Agenda Item: 6.3
Source: Alcatel
Title: Synchronization of UTRAN nodes by AAL0/ATM cells
Document for: Approval

Figure 1: Node Synchronisation procedure

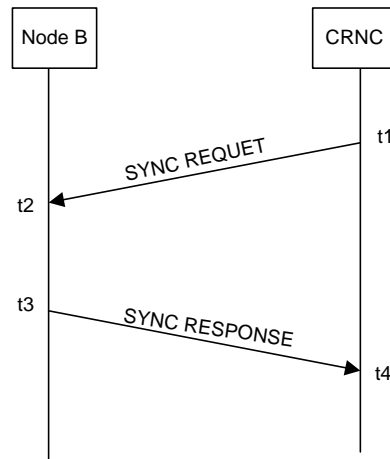
Figure 1 shows the case of CRNC / Node B synchronisation.

CRNC sends a SYNC REQUEST Control Frame to Node B. This message contains the time of transmission (t1). Upon the reception of SYNC REQUEST, Node B responds with SYNC RESPONSE which contains the time of SYNC REQUEST transmission (t1), the time of the arrival (t2) and the time of the response (t3). CRNC, using the three values together with the time of the arrival of the response (t4), calculates the timing difference as follows.

- Transmission delay $T = \{(t4 - t1) - (t3 - t2)\} / 2$
- Timing difference $X = t2 - t1 - T$

Since the AAL0/ATM synchronisation cells have the highest priority, the transfer delays can be considered in both directions as equivalent with the error of the delay variation. And the delay variation should be very low since it is the highest priority.

It is proposed to include the proposed node synchronisation procedure (Figure 1 and explanatory text) in a new section of TS 25.433 [3].
